Re: Wappinger Airport Drive LLC
Supplemental Submission in Support of Application for Amended Site Plan Approval
Premises: 26 Don Bosco Boulevard, Wappingers Falls, NY
Tax Parcel No.: 6259-04-647405

In response to comments provided by this Board, and the Board's Engineering and Planning Consultants at the Planning Board's March 3, 2025 meeting, the Site Plans prepared by Insite Engineering, Surveying & Landscape Architecture, P.C. ("Insite") have been revised to address their comments. In addition, a point-by-point response to comments letter was prepared in response to the comment memoranda from the Town's consultants, which is enclosed herein as **Exhibit A**.

RE: Wappinger Airport Drive LLC
Amended Site Plan for Don Bosco Boulevard
Tax Map No. 6259-04-647405

DRAWING: **OVERALL PLAN**

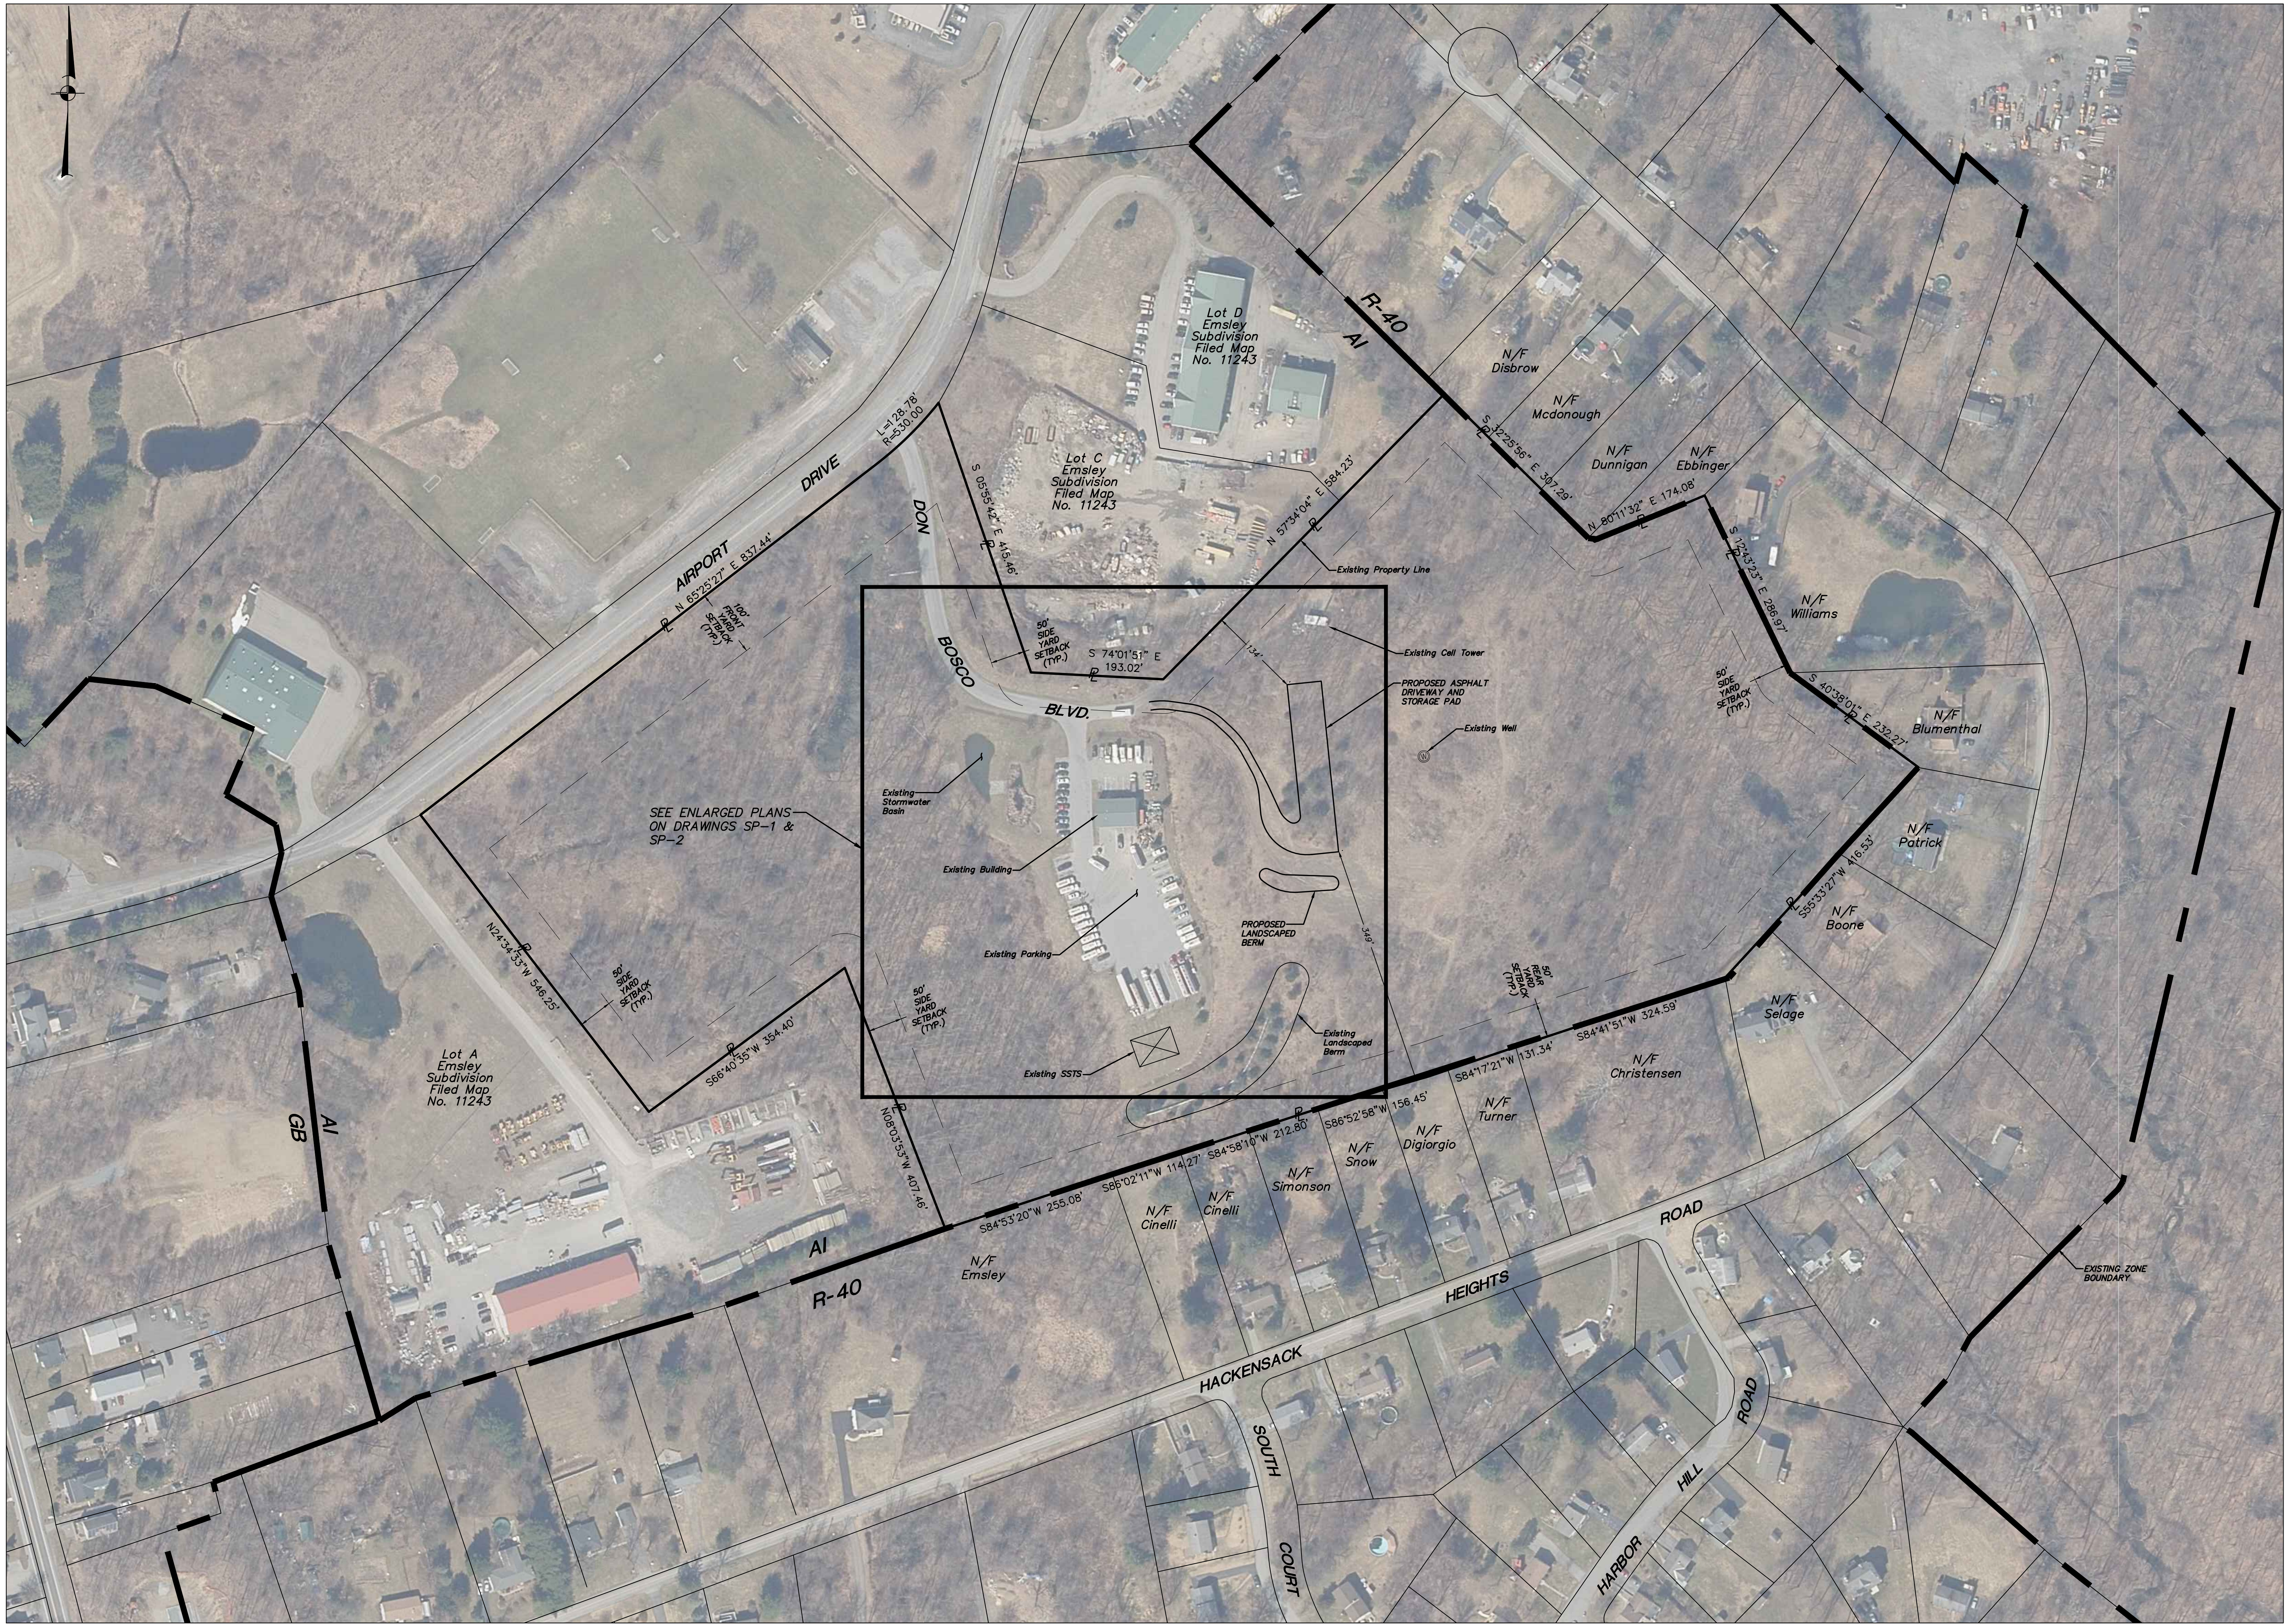
2. *Pursuant to Town Code Section 240.100.B., the maximum grade for a new driveway is 7%. The approving authority, in this case the Planning Board has the ability to permit an increase in grade up to a maximum of 10% where it can be demonstrated to the satisfaction of the approving authority that, because of practical difficulty or unreasonable hardship affecting a particular property, such an increase in grade is warranted. The proposed access drive grade is 10%. The project sponsor should submit a written request for the proposed increase along with such other information that substantiates practical difficulty or hardship.*

As discussed at the last Planning Board meeting the applicant is seeking the Planning Board to permit a maximum grade of 10% for the proposed access drive. While a 7% driveway could be accommodated it would require deep cuts and result in an unbalanced earthwork. Since the site is only to be used by trucks owned by the applicant and will not be open to the public, and a 10% driveway can be navigated by trucks, cars, and emergency response vehicles we believe the driveway as designed is appropriate for the proposed use.

- GENERAL NOTES:**
- Property lines and wetlands taken from Site Plan for Don Bosco Boulevard prepared by Powell Engineering, PLLC last revised 07-28-11. Existing features based on Map of Survey for Parcel B, Emsley Subdivision prepared by Robert V. Cawelli, last revised May 1, 2012. Topography based on Site Plan Prepared for Don Bosco Boulevard with updates from Map of Survey for Parcel B.
 - Ortho-imagery shown hereon is taken from the Town of Wappinger GIS data base, dated 2021.
 - A grade of 10% for the storage pad driveway is proposed.

DRAWING: **LAYOUT & LANDSCAPE PLAN**

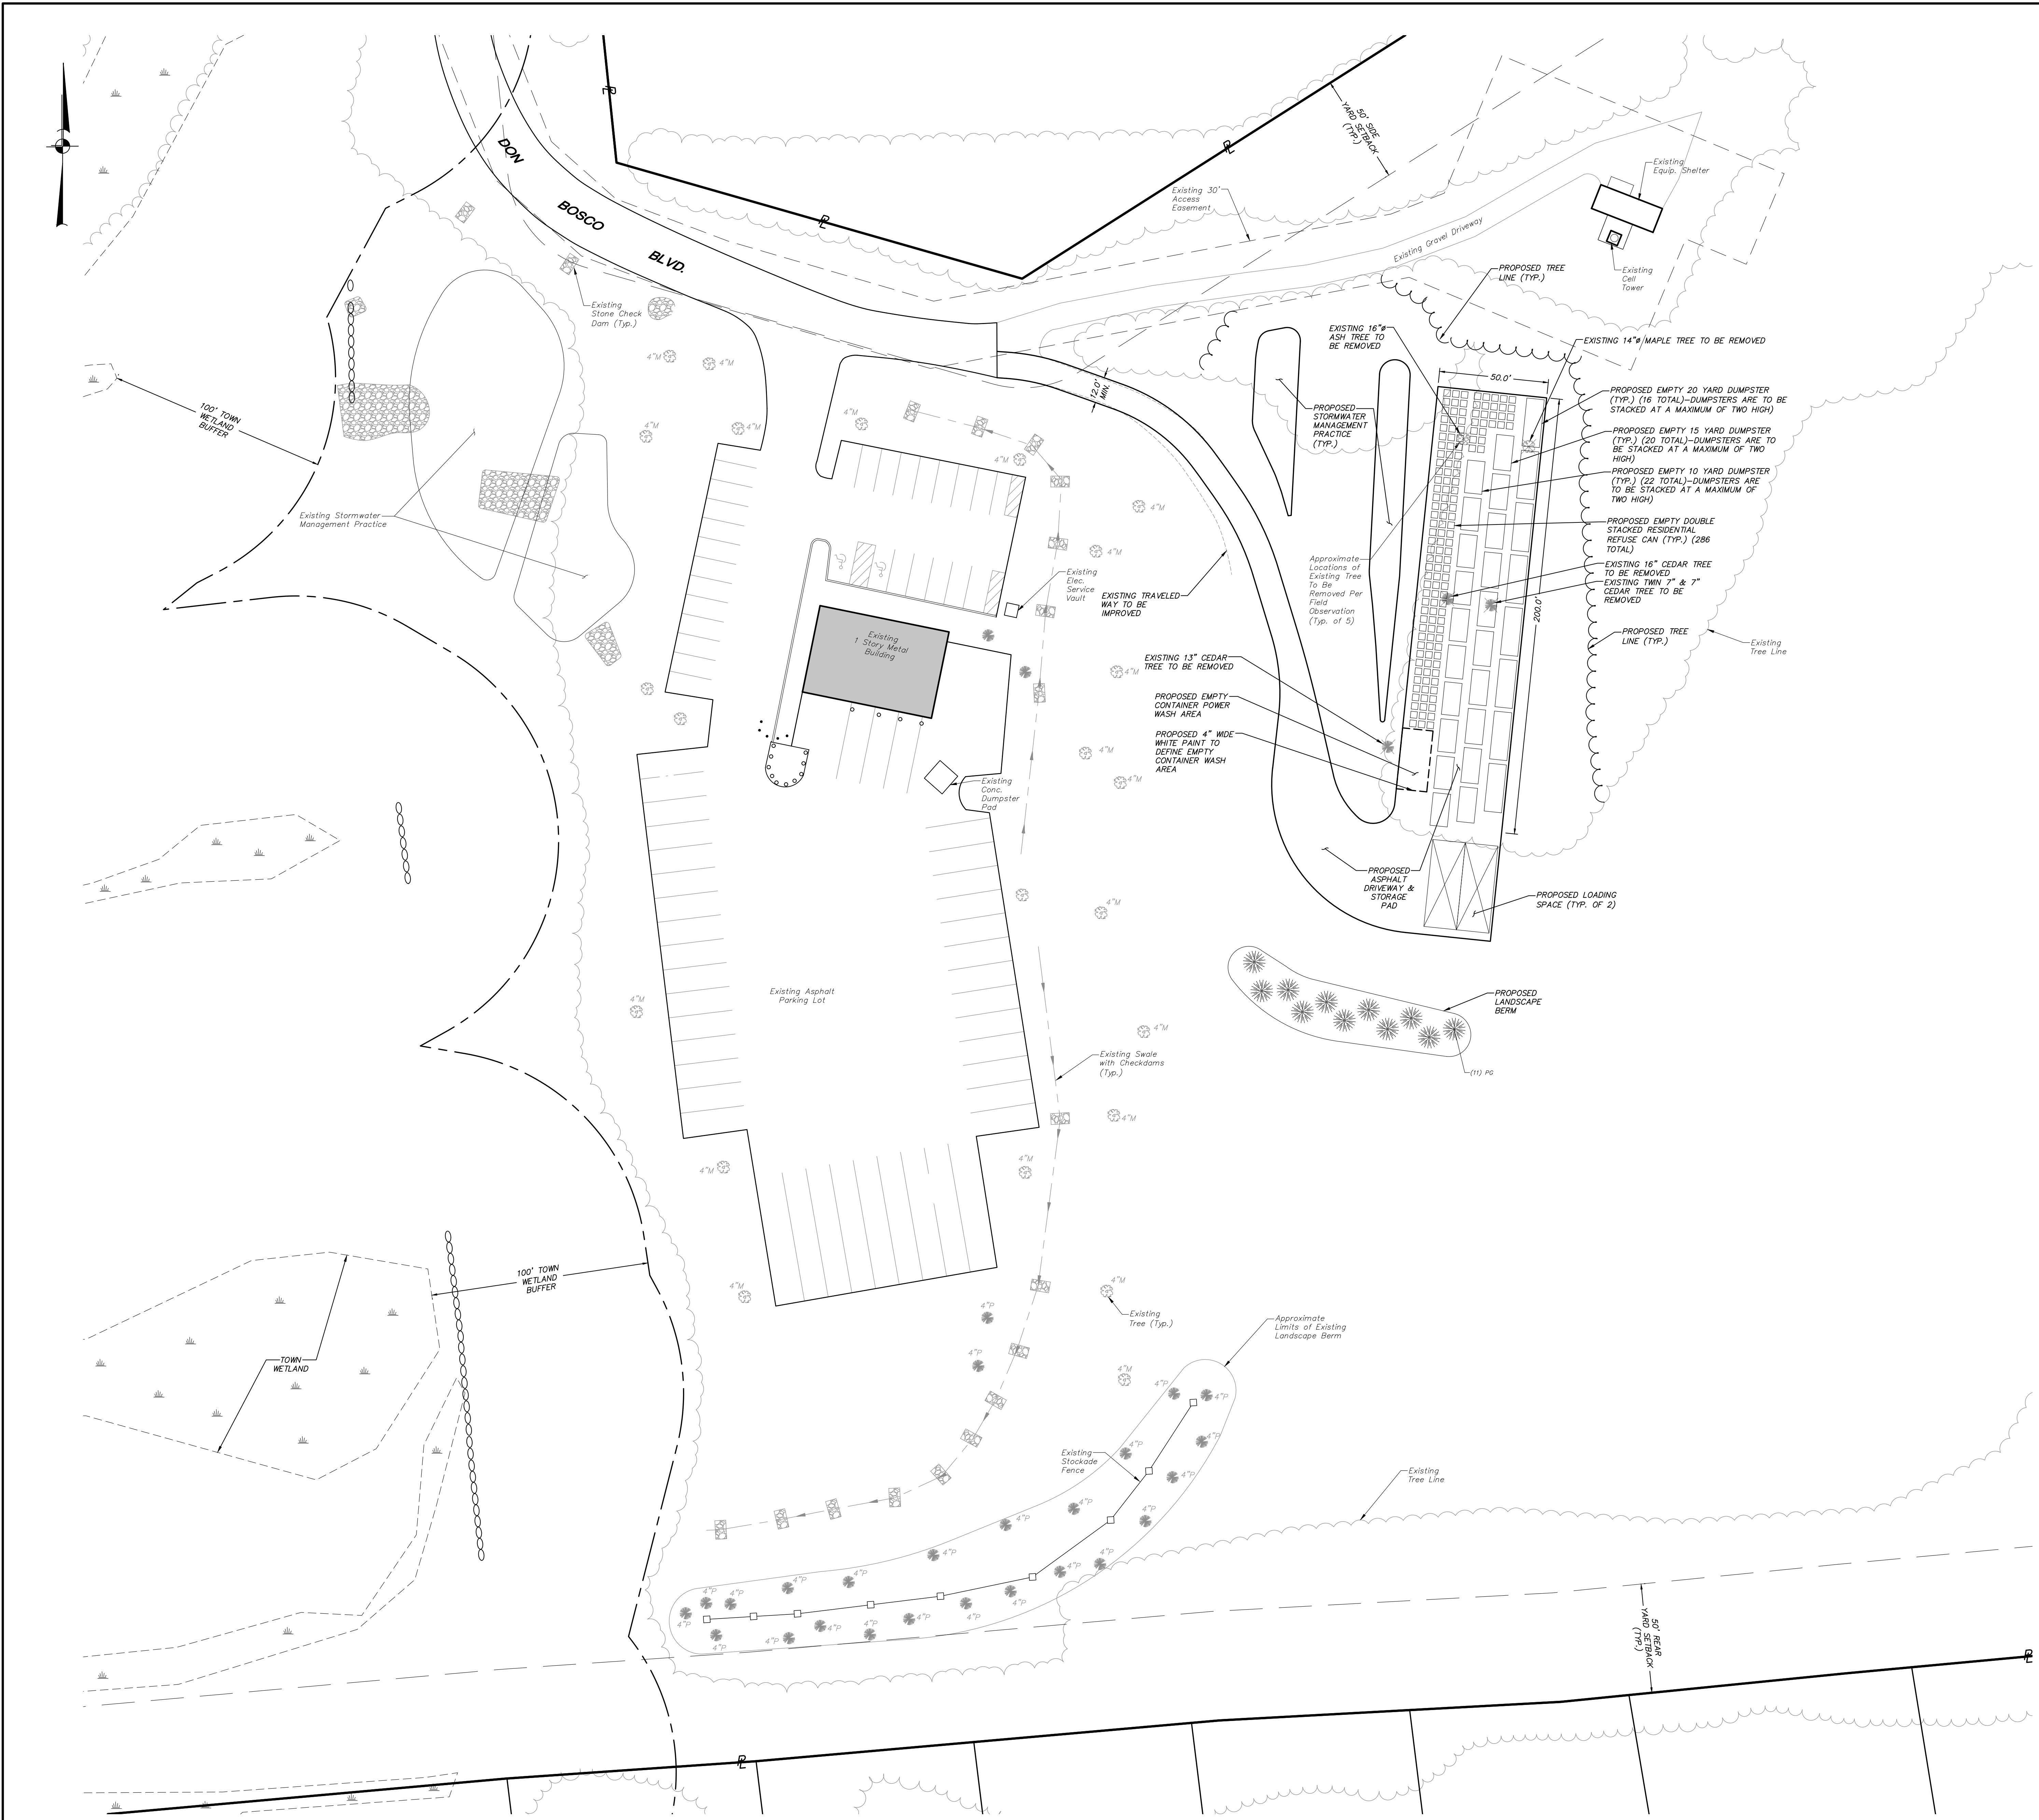
2. *The Applicant is proposing a landscaped berm to mitigate potential visual impacts and has provided photographs of the existing site. The existing use on the Site uses a vegetated berm to mitigate visual impacts to the residential neighborhood to the south. The existing berm is more robust than the one proposed and includes a stockade fence, but the existing berm and existing use are also closer to the residential neighborhood to the south. The Planning Board should consider the proposed use and proximity of it to the residential neighborhood to the south and consider the suitability of the proposed berm for mitigating the visual impacts of the proposed use*

The proposed berm has been widened and oriented per discussions at the Planning Board meeting to accommodate additional trees for screening as shown on Drawings SP-1 and SP-2.
